March 10, 2023

Subject: Small Scale Beach Nourishment (SSBN) Category II Application for Pāhonu Beach Restoration at 41-457 thru 41-479 Kalaniana'ole Highway, Waimānalo, O'ahu, 96795, Tax Map Keys (1) 4-1-001:002, (1) 4-1-001:003, (1) 4-1-001:004, (1) 4-1-001:006, (1) 4-1-001:007, (1) 4-1-001:008, (1) 4-1-001:009 and (1) 4-1-001:0012

Thank you for your comments dated November 16, 2022, regarding the Pāhonu Beach Restoration SSBN Category II Application. Your comments are reproduced in **bolded** font below with our responses directly following.

SHORELINE MAP  
TMK 4-1-001 PARCELS 002, 003, 004, 006,  
007, 008, 009, & 012  
AT WAIMANALO, CITY AND COUNTY OF HONOLULU,  
STATE OF HAWAII

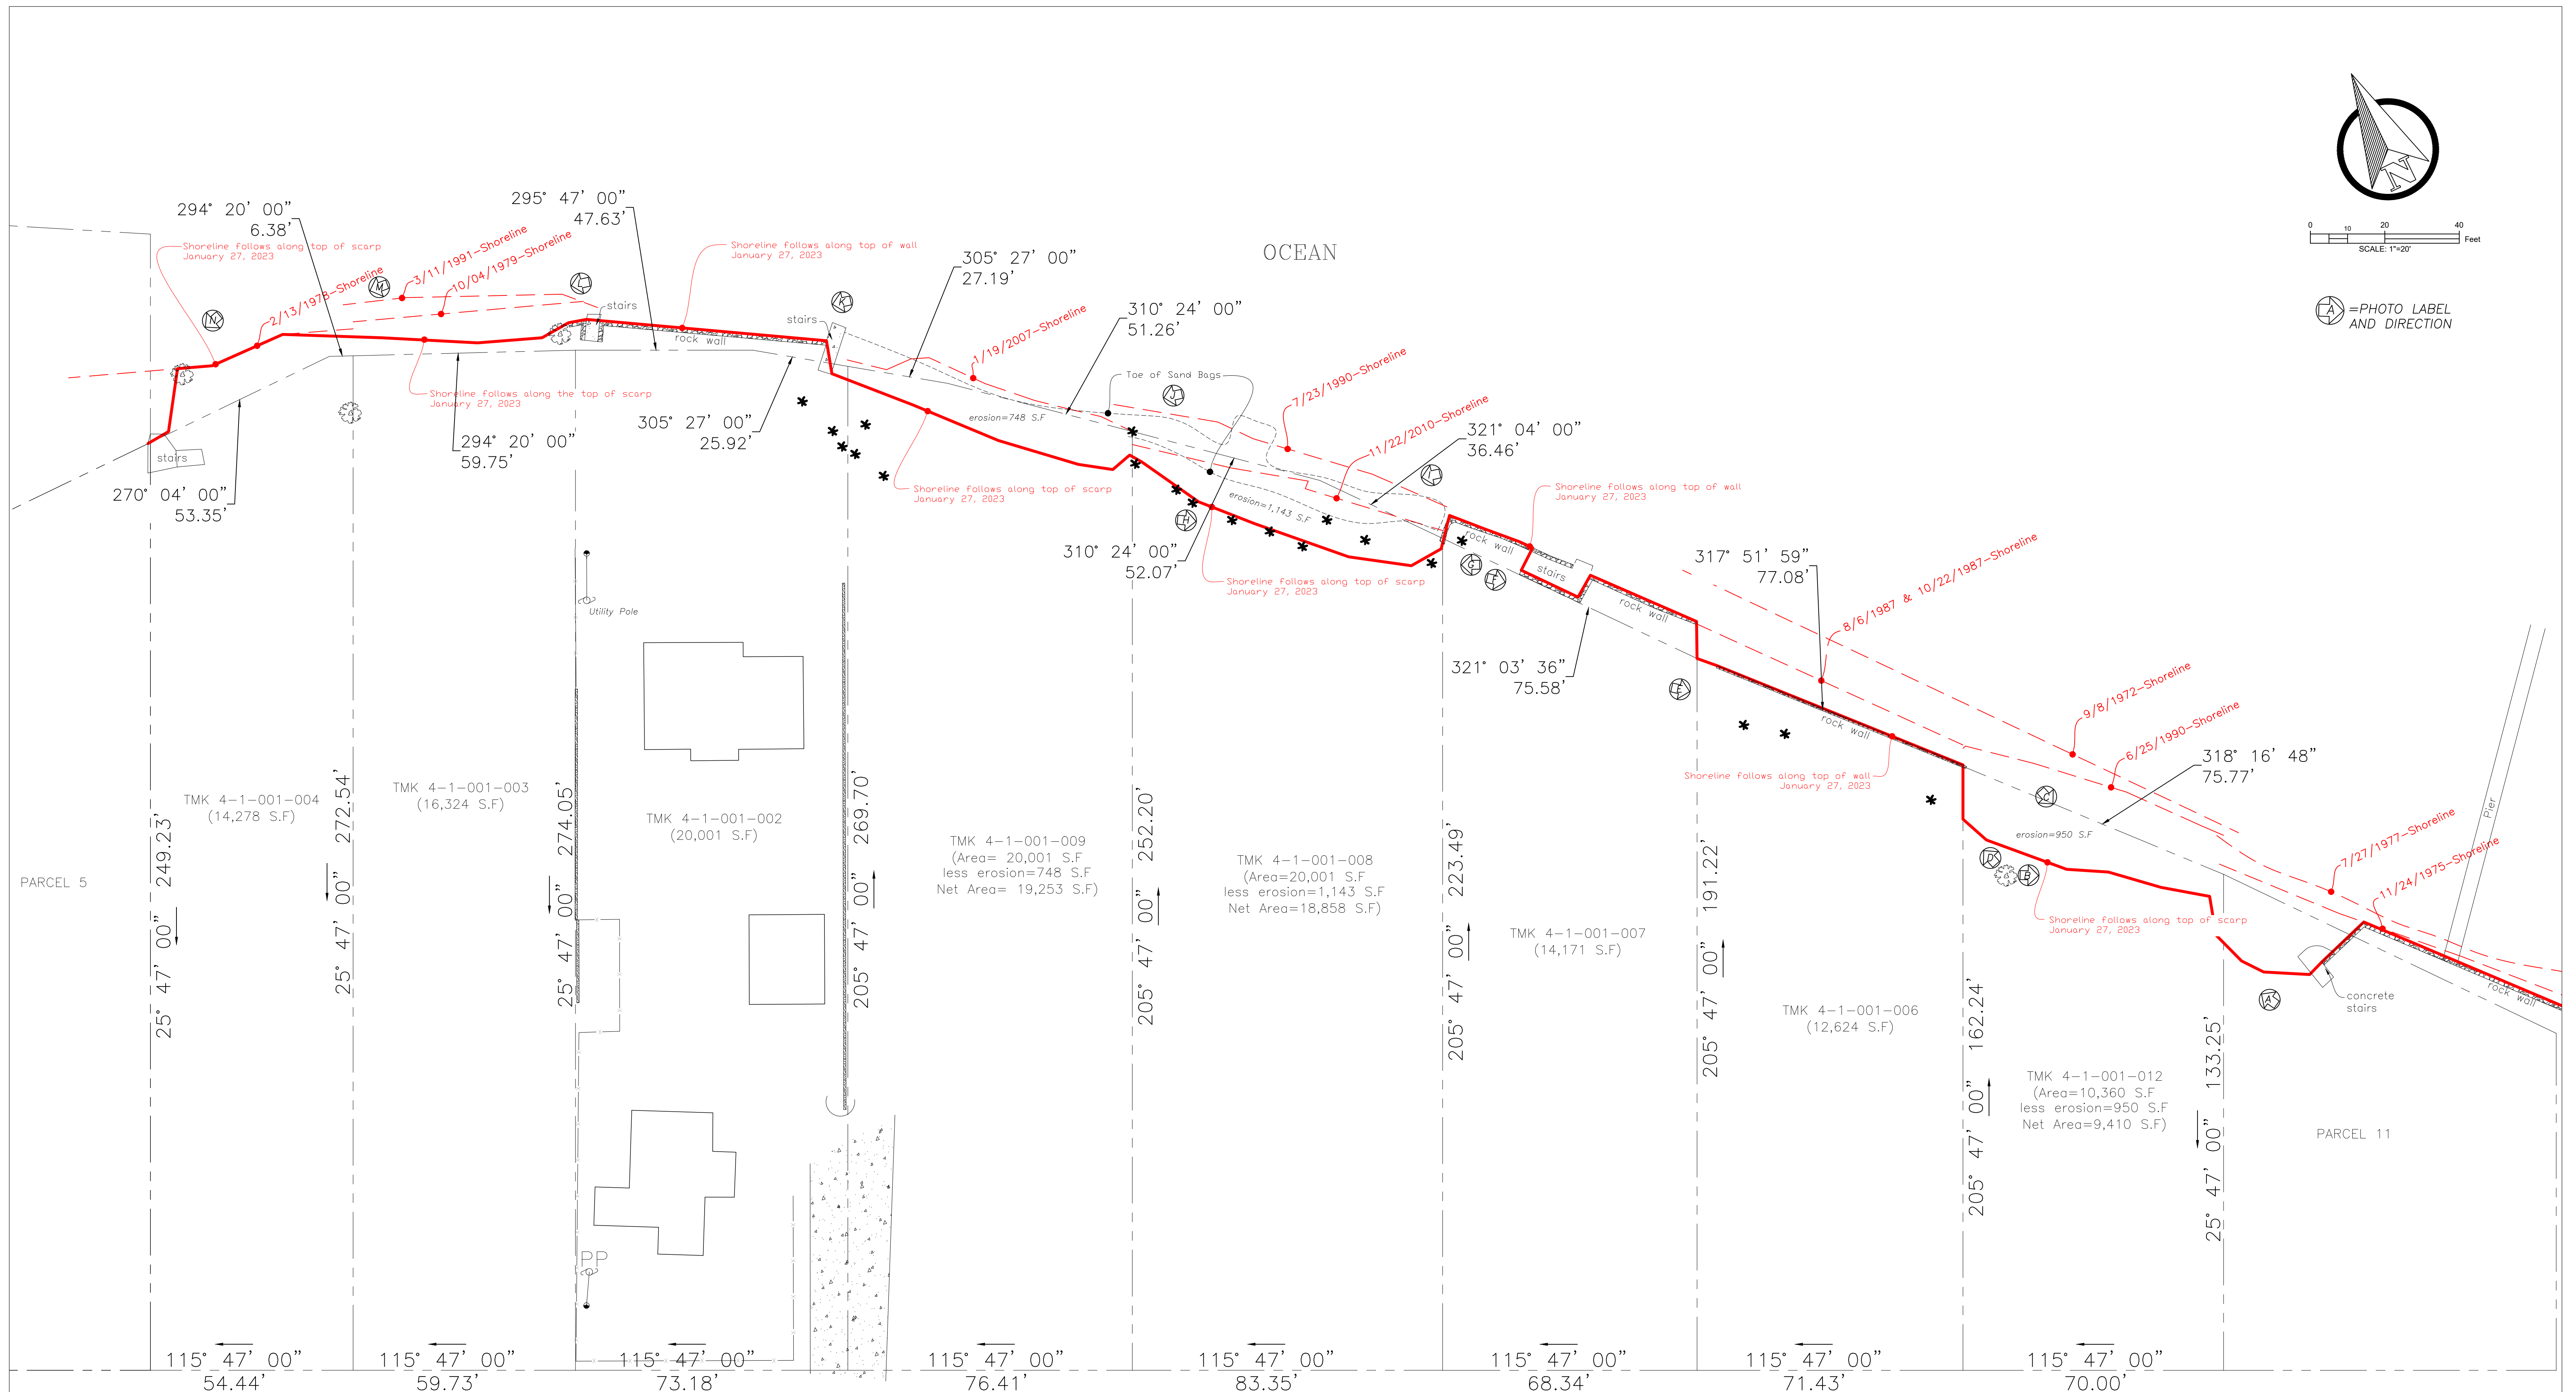
- 1. Provide a copy of a professional shoreline survey. Alternately, you can provide a current state certified shoreline map for the project location (item 5c of the SSBN application).**

Please refer to Appendix A of this letter (or newly added Attachment G of the SSBN application) for a recent professional shoreline survey of the project site. The permit drawings in Attachment C of the SSBN application have also been updated to incorporate the surveyed shoreline.
